NORTHEAST UTILITIES

Docket No. 50-336
A04089

Millstone Nuclear Power Station, Unit No. 2
Additional Information for Generic Letter 82-28

ATTACHMENT 1
REQUEST FOR ADDITIONAL INFORMATION
ON NRC LETTER 82-28

Figure
4

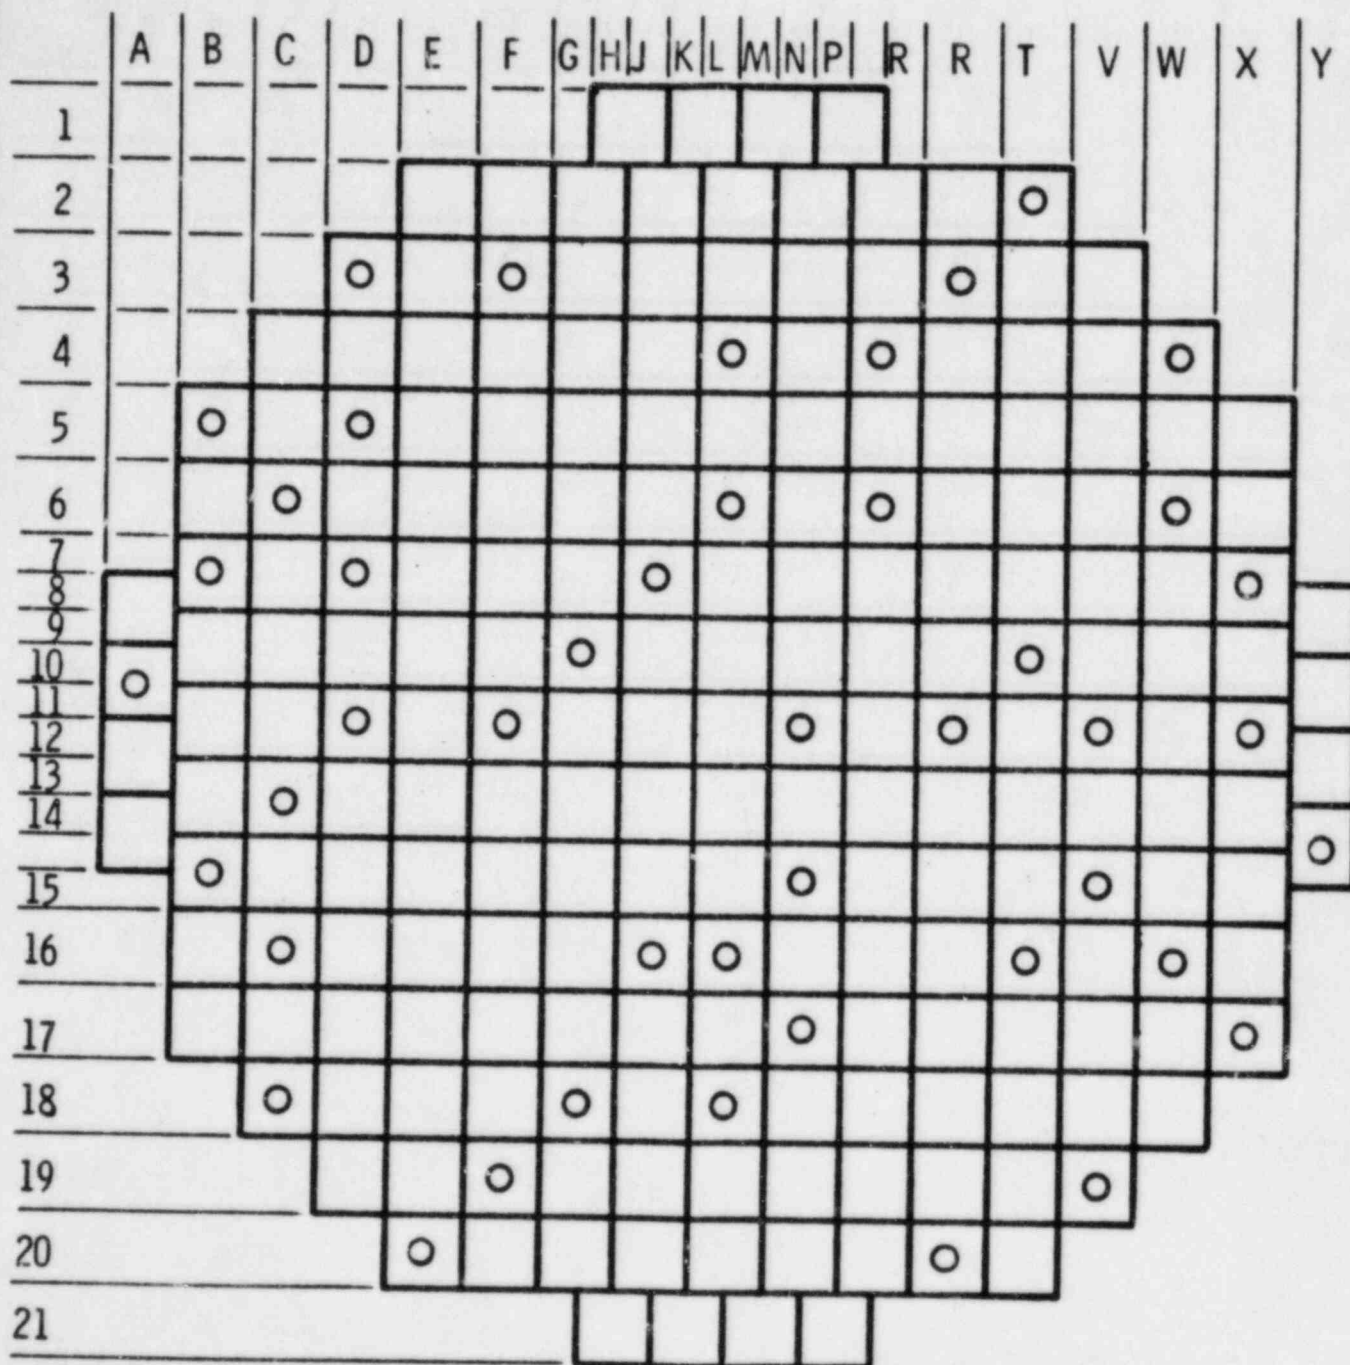
1. Provide diagram of core exit thermocouple locations or reference the generic description if appropriate.

Refer to Figure 4 (Attached)
